EXPOSITION LIGHT RAIL TRANSIT PROJECT- PHASE 2, DESIGN BUILD CONTRACT NO. XP8902-002

CDRL SUBMITTAL 01102-3.3.3.11A - FINAL CIVIL SEGMENT 3C CITY OF SANTA MONICA
APPROVED FOR CONSTRUCTION - OCTOBER 19, 2012

ROADWAY IMPROVEMENTS

CONTRACT NO XP8902-002
DRAWING NO UW-3C-202 REV 1
SCALE HOR: 1"=20' VERT: 1"=4'
SHEET NO 54 OF 108

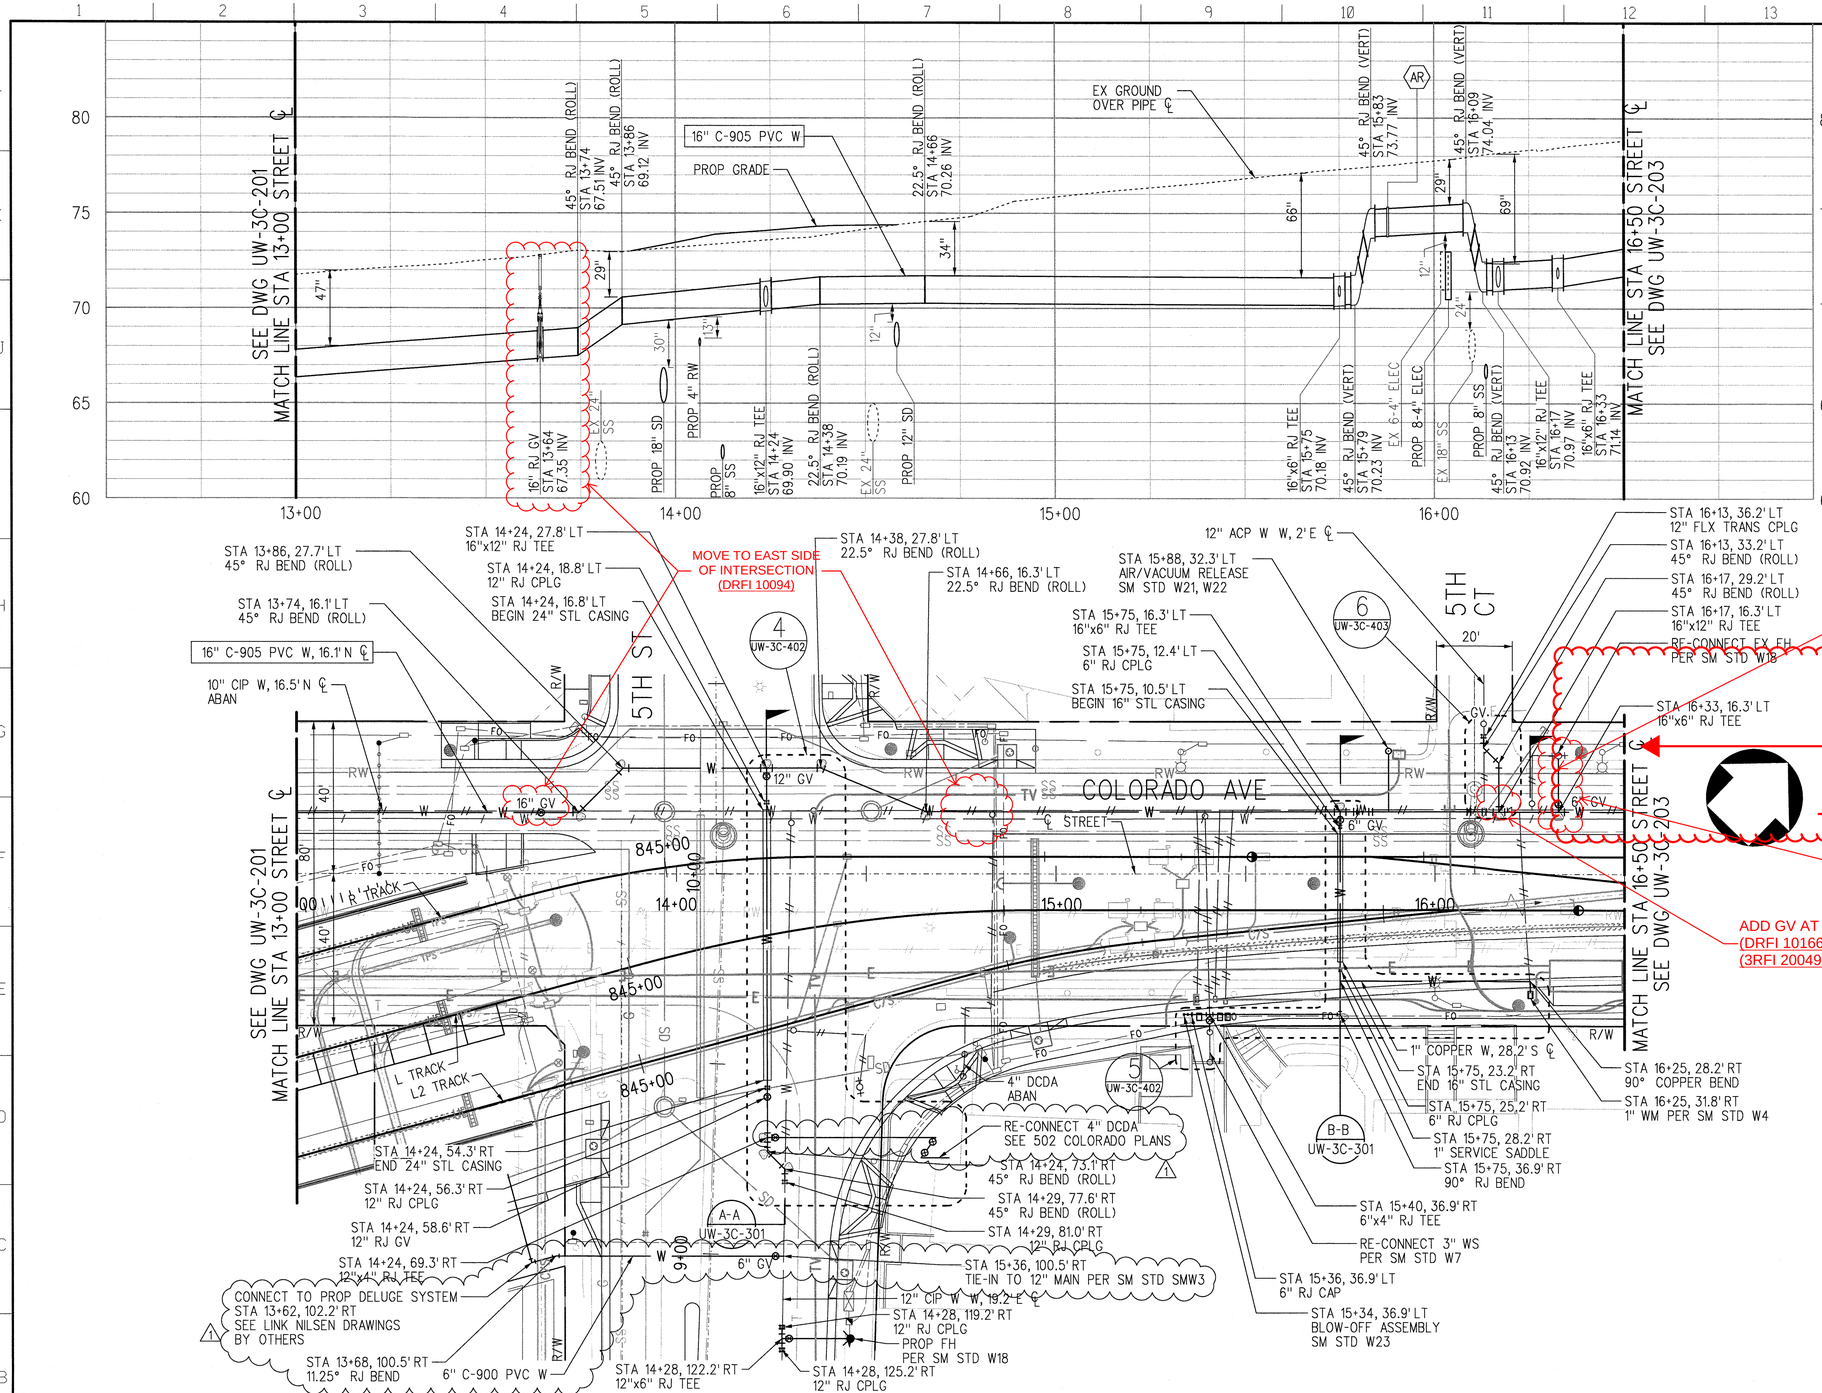
CONTRACTOR TO PROVIDE JOINT RESTRAINTS FROM 45 DEGREE BEND AT 14+66 TO EASTERLY. PLEASE SUBMIT TYPE OF RESTRAINT TO BE USED FOR CITY APPROVAL PRIOR TO CONSTRUCTION.
(DRFI 10165)
(3RFI 20048)

CONTRACT NO XP8902-002
DRAWING NO UW-3C-203 REV 0
SCALE HOR: 1"=20' VERT: 1"=4'
SHEET NO 55 OF 108

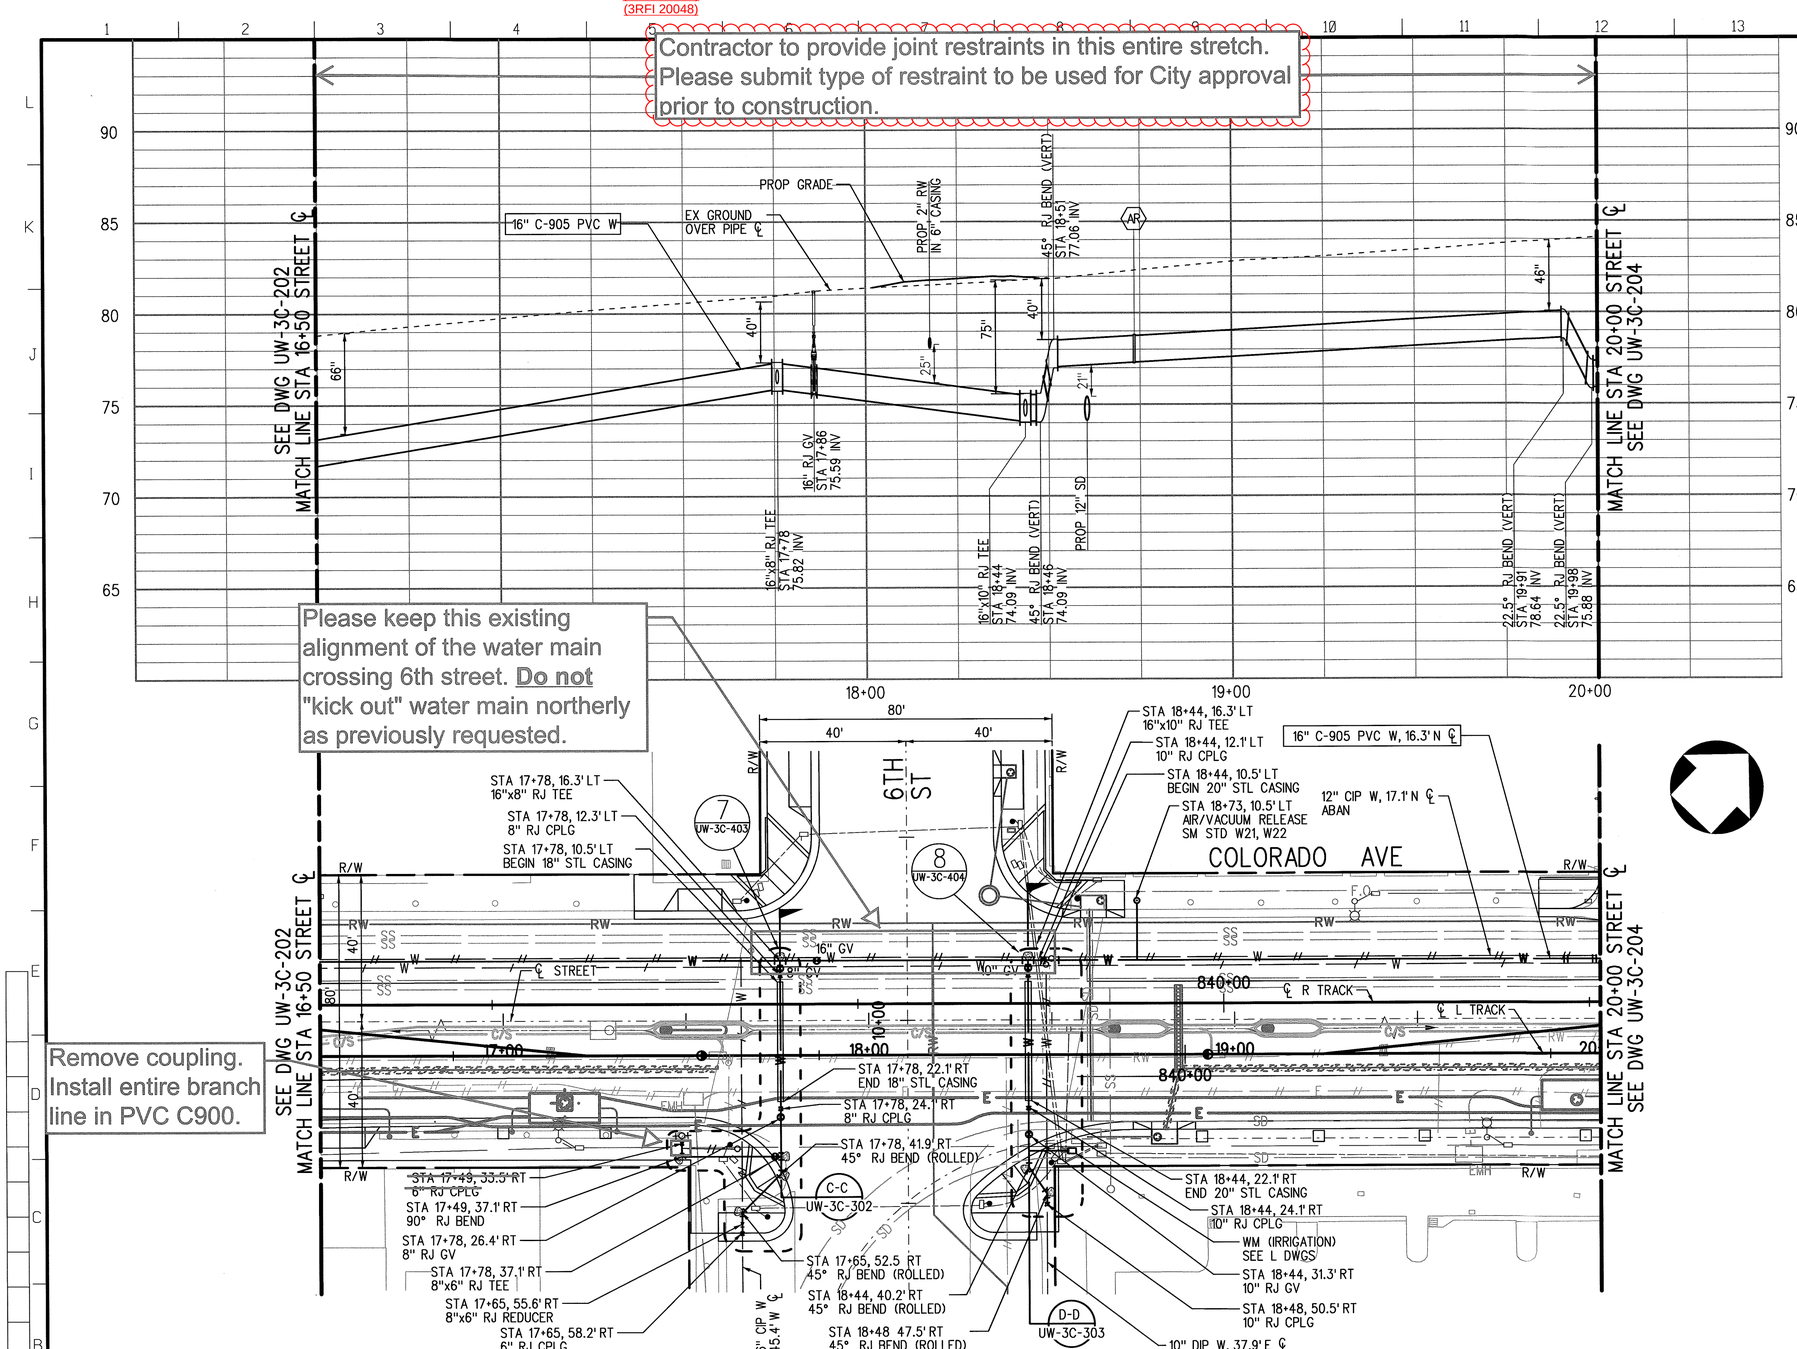
Contractor to provide joint restraints in this entire stretch. Please submit type of restraint to be used for City approval prior to construction.

Please keep this existing alignment of the water main crossing 6th street. **Do not** "kick out" water main northerly as previously requested.

CONTRACT NO XP8902-002
DRAWING NO UW-3C-204 REV 0
SCALE HOR: 1"=20' VERT: 1"=4'
SHEET NO 56 OF 108

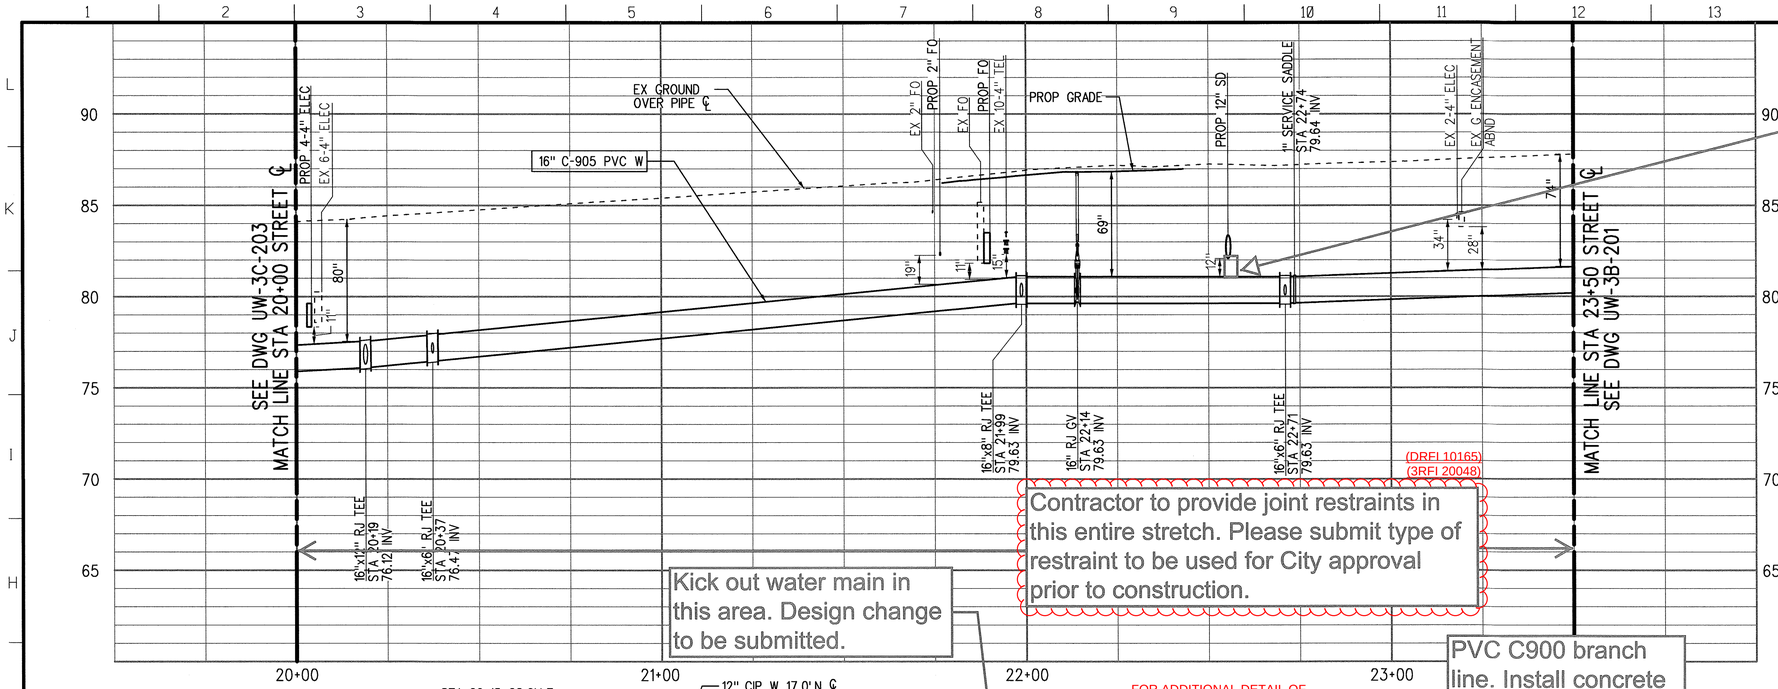
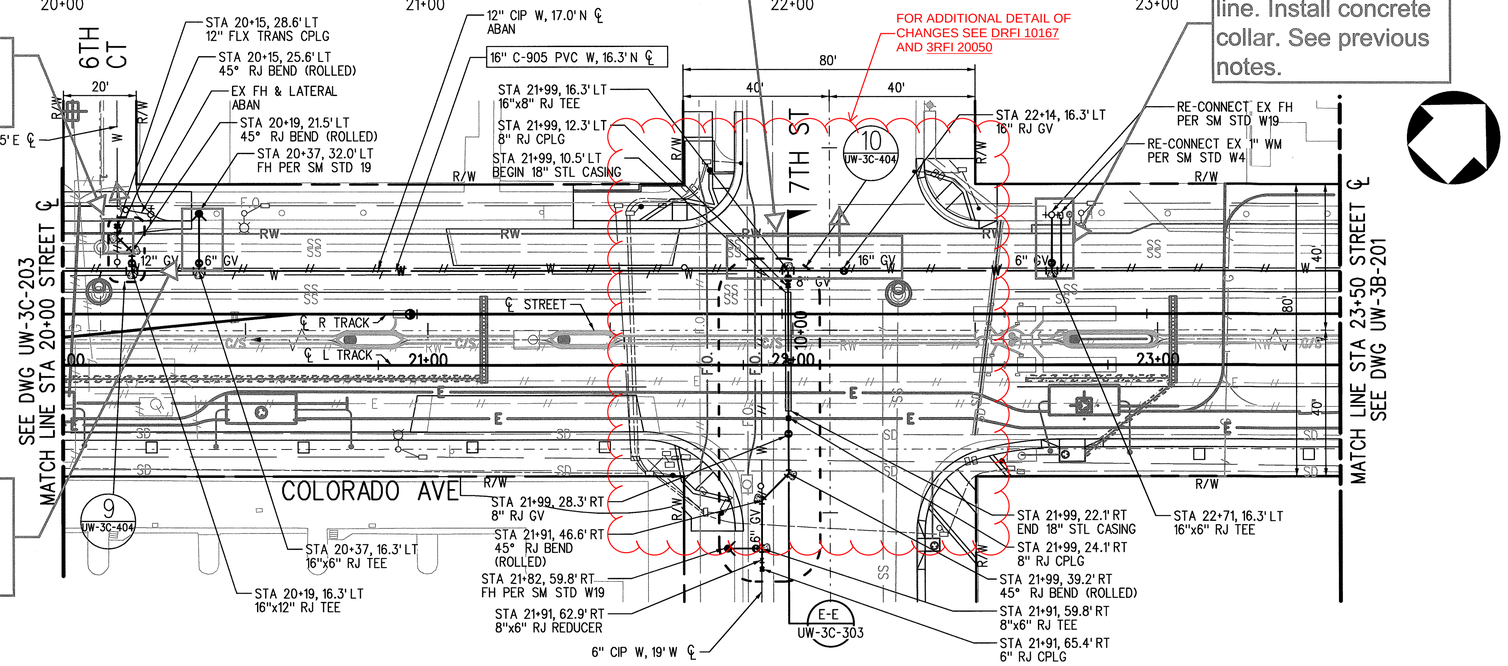
No water joints within 10' on each side of SD (if separation under 12"). Field verify.

Kick out water main in this area. Design change to be submitted.

FOR ADDITIONAL DETAIL OF CHANGES SEE DRFI 10167 AND 3RFI 20050

CONTRACT NO XP8902-002
DRAWING NO UR-3C-300 REV 0
SCALE NO SCALE
SHEET NO 83 OF 108

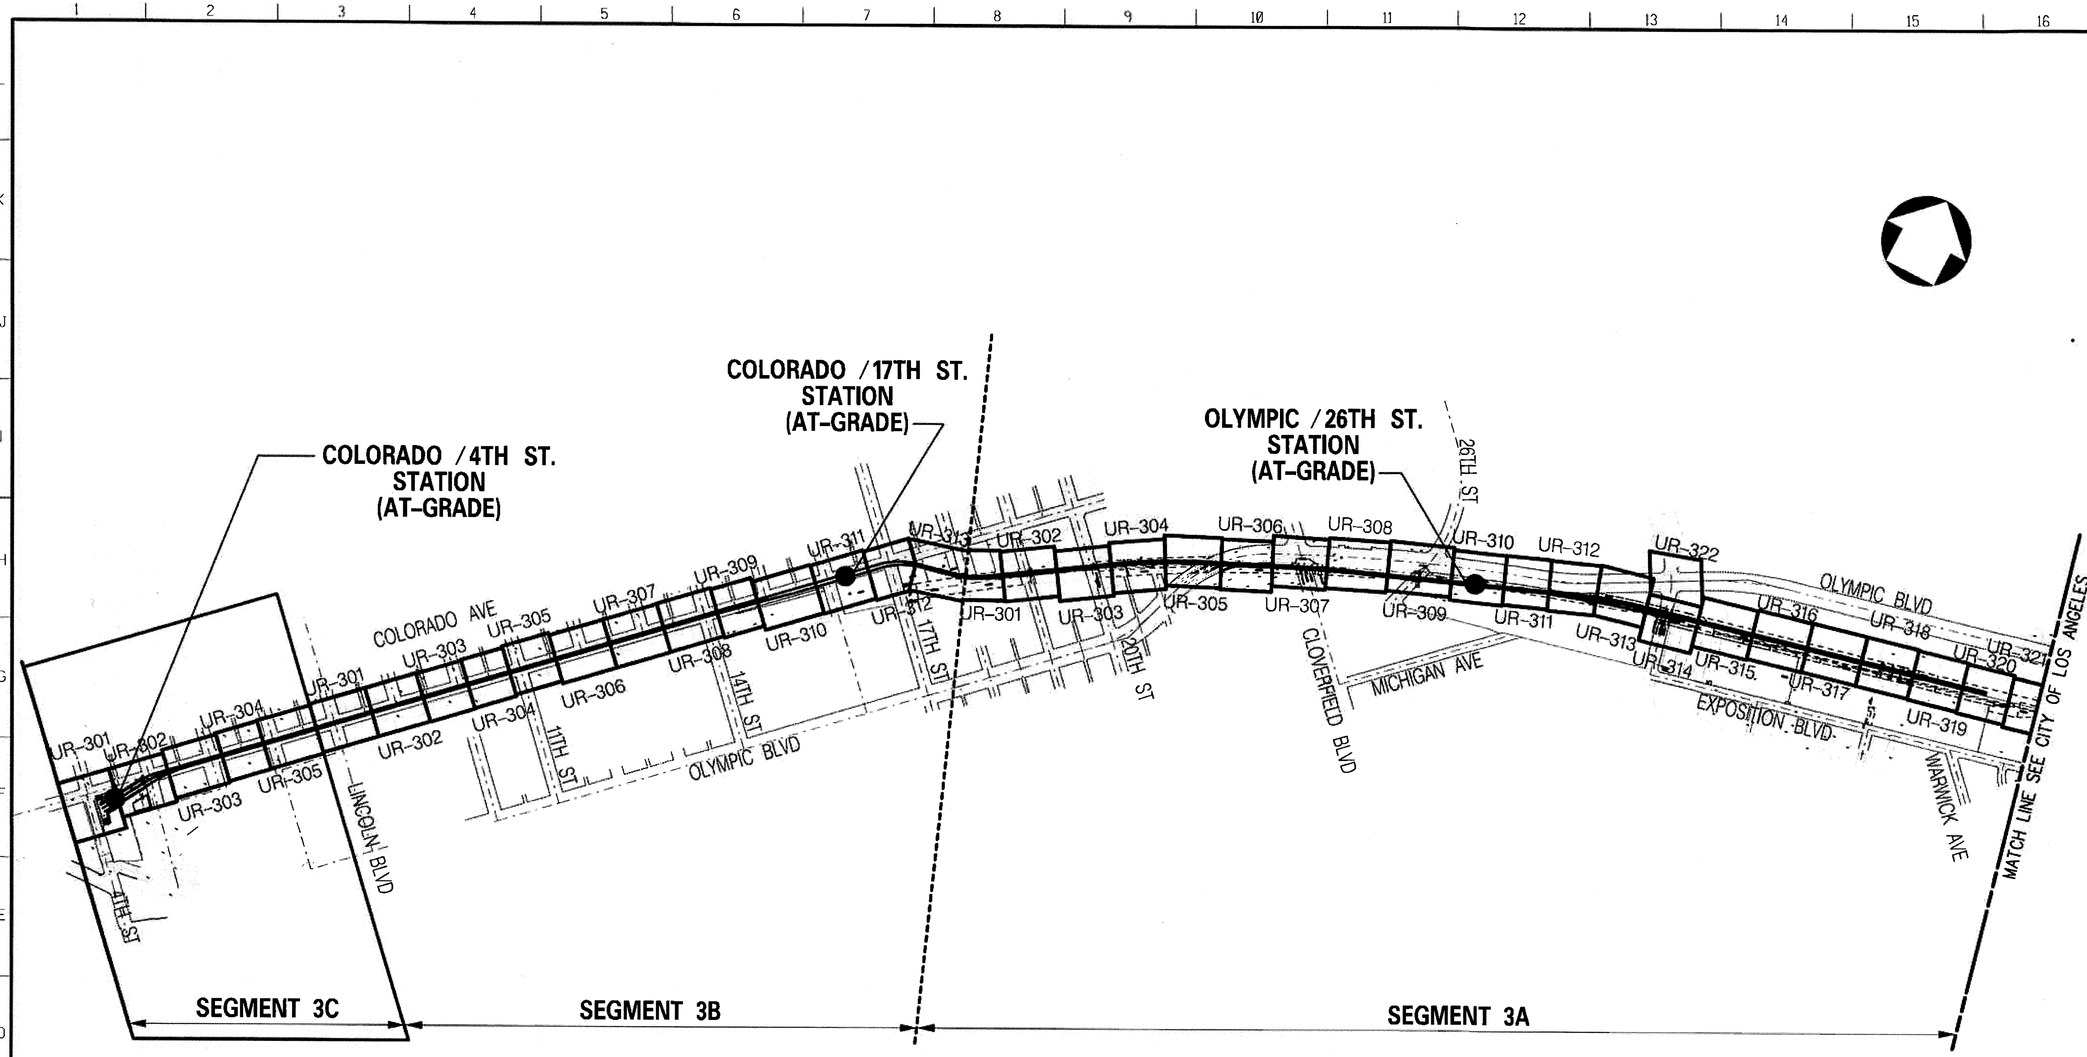
Please submit final record set of Utility Rearrangement Locations after construction of all utilities.
